Station Road, Warnham

Technical Note 001 V1.1

Client:	Wienerberger Ltd	Job No	J328671
Date:	23 June 2026	Approved by:	MF
Prepared by:	CB

- 1.1.1 This Technical Note (TN) has been prepared by mode transport planning (mode) on behalf of Wienerberger Ltd, with respect to a planning application (ref: DC/26/0585) for a proposed residential development of up to 24 dwellings at land located north of Station Road, Warnham.

PROPOSED A24 PEDESTRIAN CROSSING

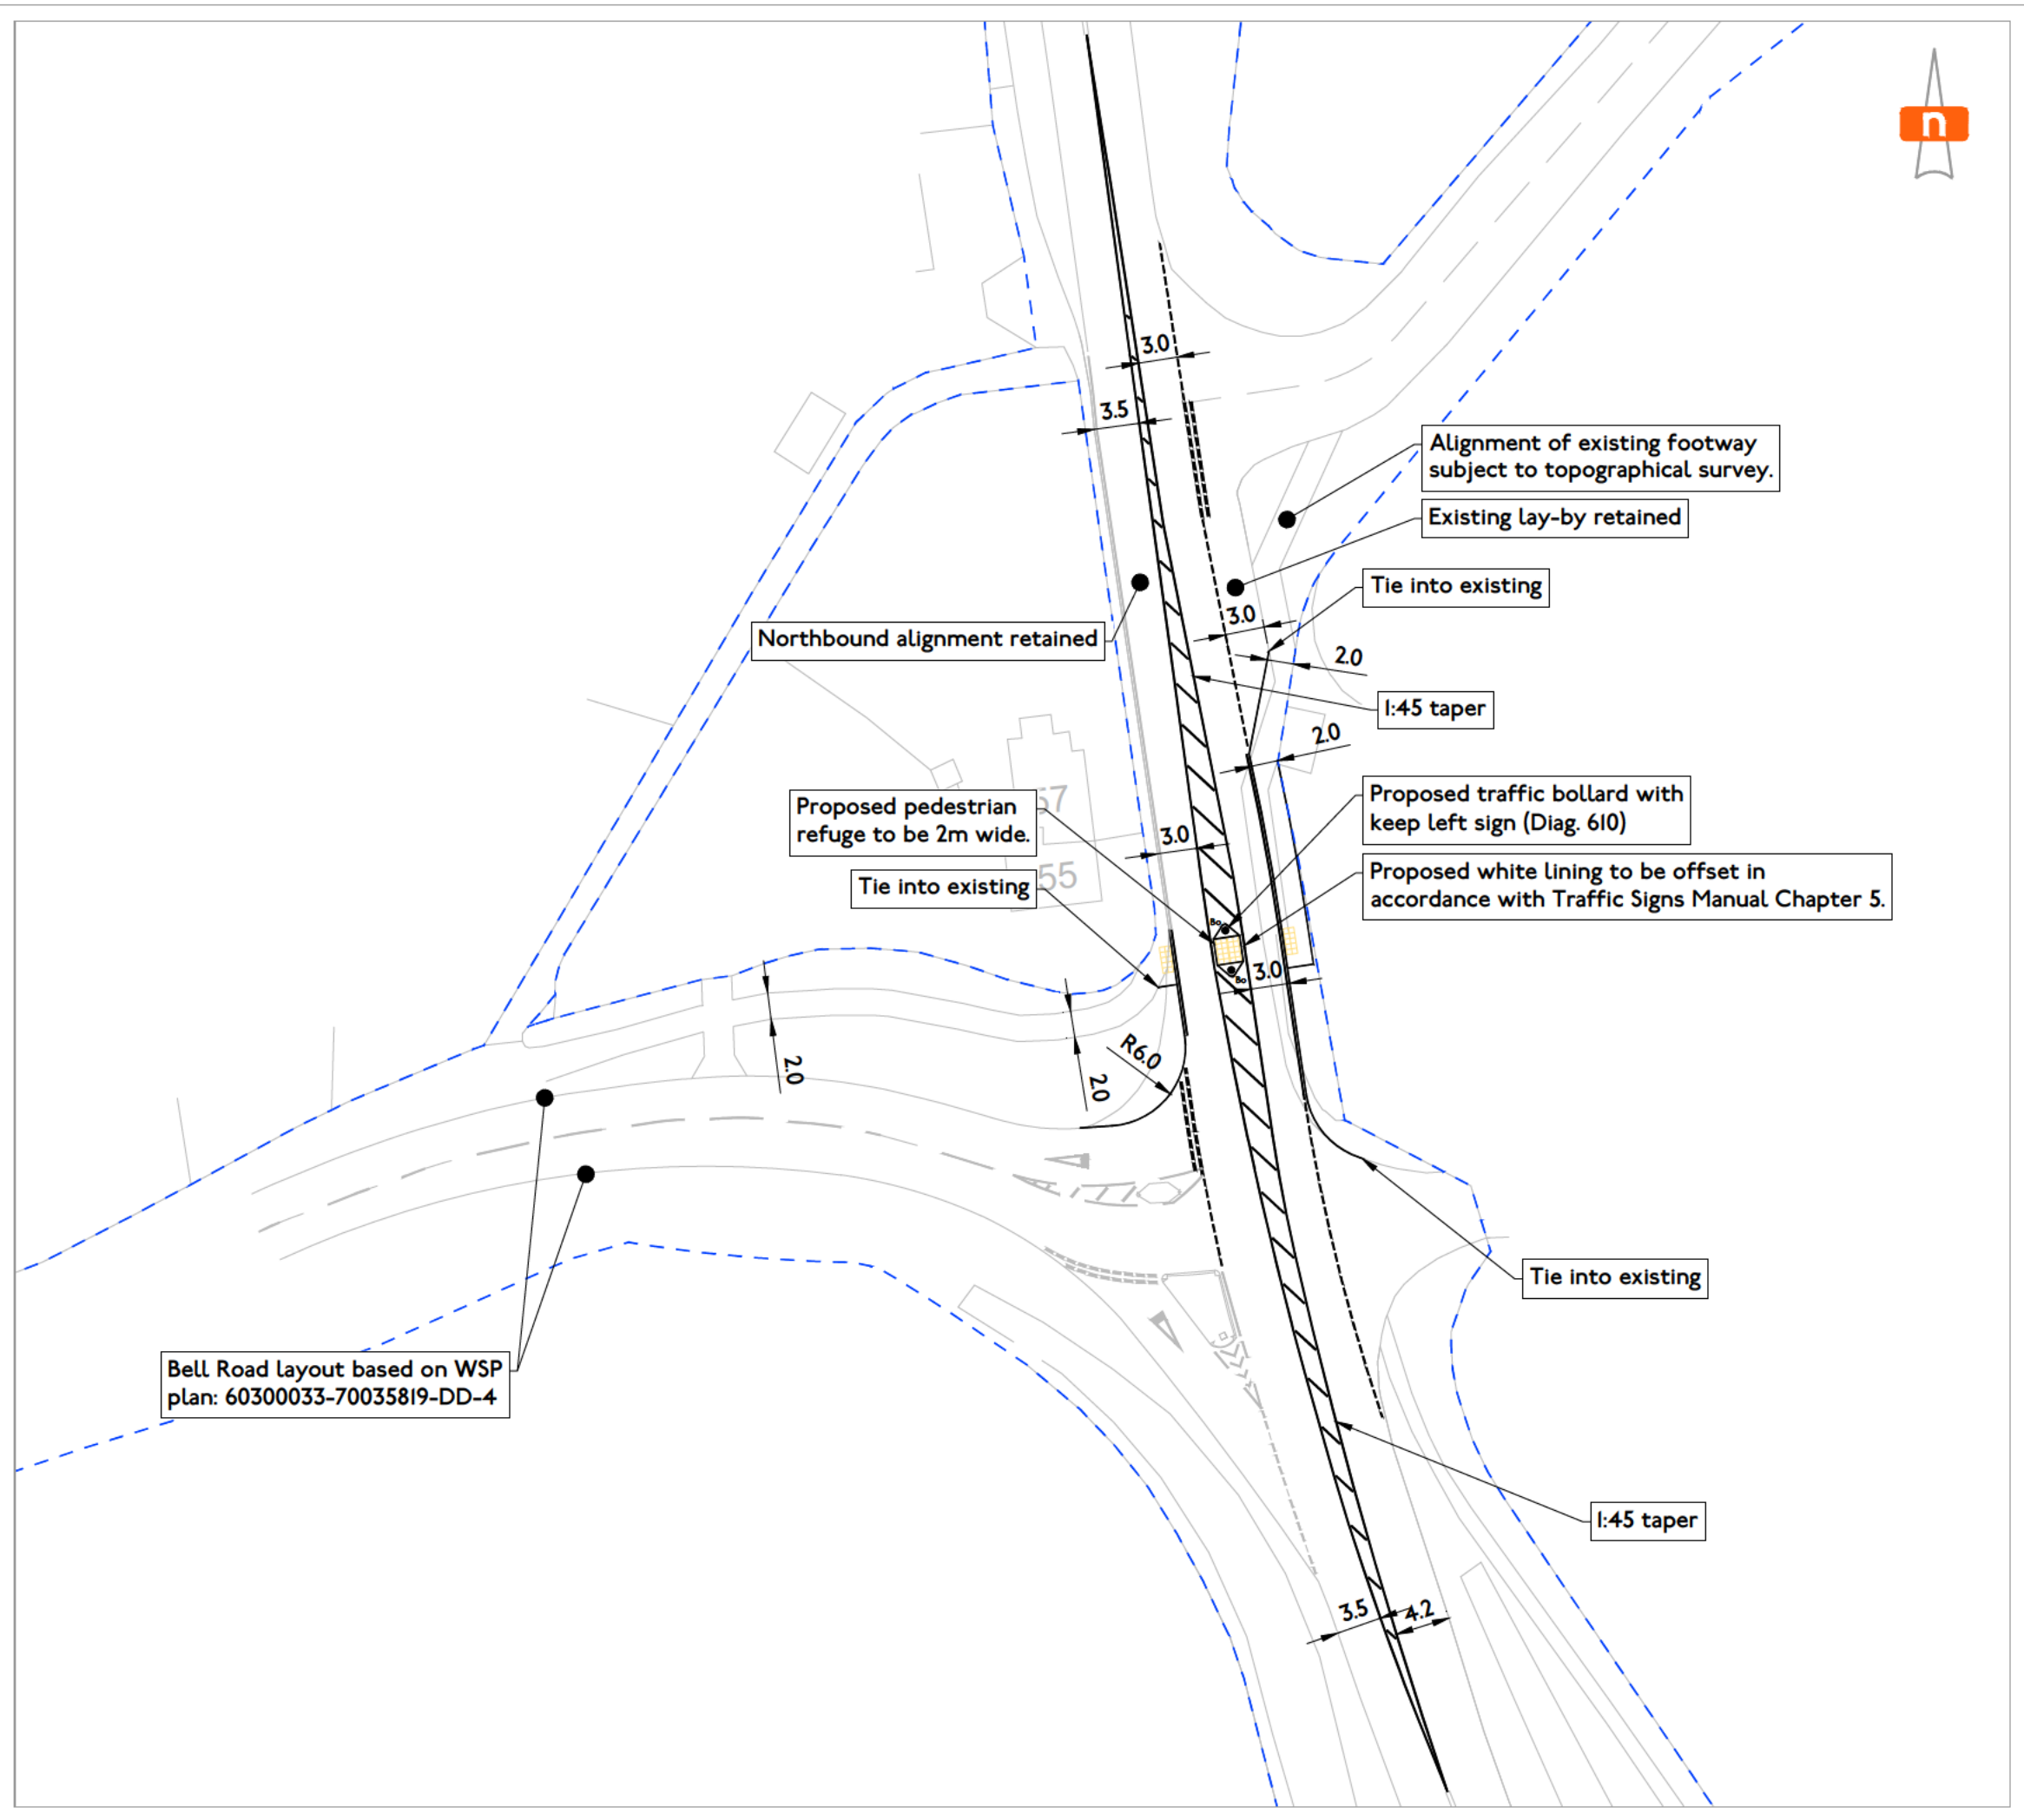
“The LHA has reviewed the highway improvement works on the A24/Station Road/Bell Road as proposed by the applicant on drawing J32-5244-PS-005 Rev C. Notwithstanding changes may be required as part of a revised RSA the LHA would offer the following comments following assessment of the plan and supporting information:

The crossing point is too close to the junction and needs to be amended to reduce risk of pedestrians from turning vehicles. The crossing is shown located within skewed kerbline of the A24.

The footway width on the western side tactile paving appears to be barely a metre wide. This will be too narrow for eastbound pedestrians waiting to cross the A24. It is shown as equivalent to 2 tactile paving slabs width (800mm)

The width of the refuge island in the ghost island at absolute minimum (1.5m). This will not be suitable for wheelchairs, pushchairs and dismounted cyclists. This will result in poor comfort and safety perceptions. Consideration to be given to widening the depth of the refuge island. CD 143 recommends:

2.2.2 Following receipt of the LHA comments and the updated RSA, the pedestrian crossing arrangement has been revised in line with feedback received. The amendments to the design are summarised as follows, with further detail of the updated Stage 1 RSA (RSA1) set out in the associated Designers Response, provided in [Appendix C](#).

- Widening of pedestrian refuge.
- Amendments to junction radii at the Bell Road / A24 junction, to facilitate greater separation between the crossing point and junction.
- Swept path analysis to inform the above.

2.2.3 The revised arrangement is demonstrated on [mode drawing J32-8671-PS-005 Rev E](#), provided in [Appendix C](#).

Appendix C Problem Location Plan

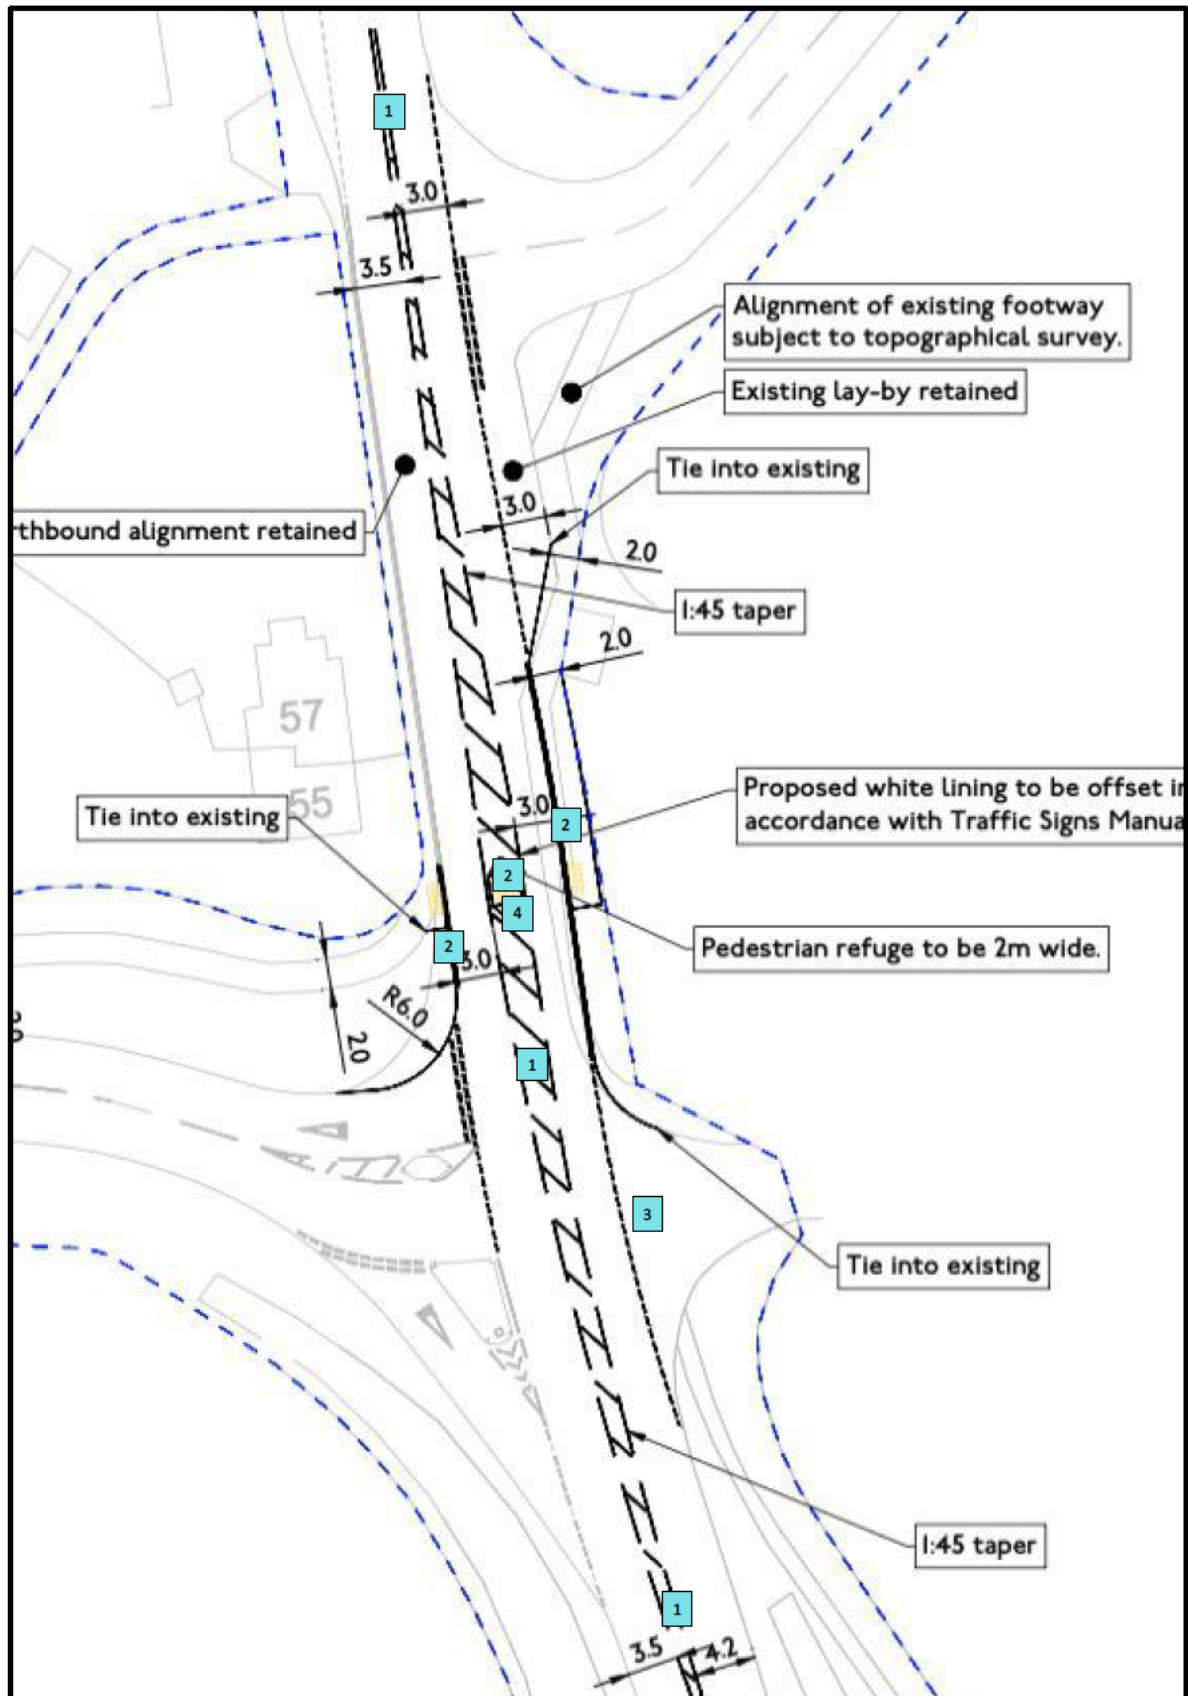
Problem 1	
Location	Staggered junction
Summary	Risk of head-on collisions
  There are existing double solid white centre line road markings through the junction, which is assumed to prevent vehicles overtaking on approaches to bends. The proposed refuge layout includes broken lines for the hatched area. This may cause drivers to attempt to overtake on approach to the junction. This may result in head-on collisions with on-coming vehicles.	
Recommendation	Amend the road markings to be consistent with the road markings in advance of the junction.

Problem 2	
Location	Pedestrian crossing
Summary	Risk of collisions with pedestrians
The proposals include a new pedestrian crossing facility to the north of Bell Road. Pedestrian intervisibility splays have not been shown for the refuge crossing facility. This may cause pedestrians not to be able to detect approaching vehicles. This may result in vehicles colliding with pedestrians stepping into the carriageway.	
Recommendation	Ensure pedestrian intervisibility splays can be achieved.

Problem 3	
Location	Residential access
Summary	Risk of side-swipe collisions
 The proposals include carriageway widening on the eastern side of Dorking Road. This will cause the new kerbline to be closer to the gates of a residential property immediately south of Bell Road, which may reduce the visibility splay achievable from the access. This may prevent exiting vehicles from detecting approaching vehicles and may result in side-swipe collisions with passing vehicles.	
Recommendation	Ensure appropriate visibility splays can be achieved.

Location	Pedestrian refuge
Summary	Risk of collisions with pedestrians or kerbs

The vertical alignment of Dorking Road undulates and the horizontal alignment meanders. This may cause the pedestrian refuge island not to be detected by approaching vehicles on bends and on inclines. This may result in collisions with pedestrians or the refuge island.

Recommendation	Provided high-level 'Keep Left' signage at the refuge.
----------------	--

RSA Problem	RSA Recommendation	Design Response Organisation	Overseeing Organisation Response	Agreed RSA Response
Problem 1 Location: A24 / Station Road / Bell Road Junction The proposed hatch markings may encourage overtaking where double solid white line markings currently exist.	Amend the road markings to be consistent with the road markings in advance of the junction.	Problem – Accepted Recommendation – Agreed The road marking arrangement has been reviewed and amended, including for solid white lines to discourage overtaking manoeuvres in this area.	-	-
Problem 2 Location: Pedestrian Refuge Island Pedestrian intervisibility splays have not been demonstrated.	Ensure pedestrian intervisibility splays can be achieved.	Problem – Accepted Recommendation – Agreed Pedestrian intervisibility requirements have been assessed in accordance with DMRB standards for a 40mph speed limit road. Pedestrian visibility splays have been taken 120m set back 1.5m.	-	-

Problem 3 Location: Residential Access South of Bell Road Carriageway widening may affect visibility from an existing residential access.	Ensure appropriate visibility splays can be achieved.	Problem – Accepted Recommendation – Agreed Visibility from the existing residential access located immediately south of Bell Road has been reviewed as part of the detailed design assessment. Visibility splays have been assessed in accordance with DMRB standards applicable to a 40mph road. A visibility splay of 2.4m x 120m can be achieved to the north, in the	-	-

RSA Problem	RSA Recommendation	Design Response Organisation	Overseeing Organisation Response	Agreed RSA Response
		direction of the proposed highway improvements. The proposed carriageway widening does not adversely affect visibility in this direction. To the south, the existing achievable visibility is approximately 2.4m x 55.2m. This visibility constraint reflects the existing highway environment and is not affected or altered by the proposed scheme. The proposed junction improvements therefore do not result in any material reduction in visibility from the residential access and the Audit Team's concern has been satisfactorily addressed.		
Problem 4 Location: Pedestrian Refuge Island The refuge island may not be sufficiently conspicuous to approaching drivers.	Provide high-level 'Keep Left' signage at the refuge.	Problem – Accepted Recommendation – Agreed Appropriate traffic signs, including "Keep Left" bollards and associated signing, have been incorporated within the design to improve conspicuity of the refuge island for approaching vehicles.
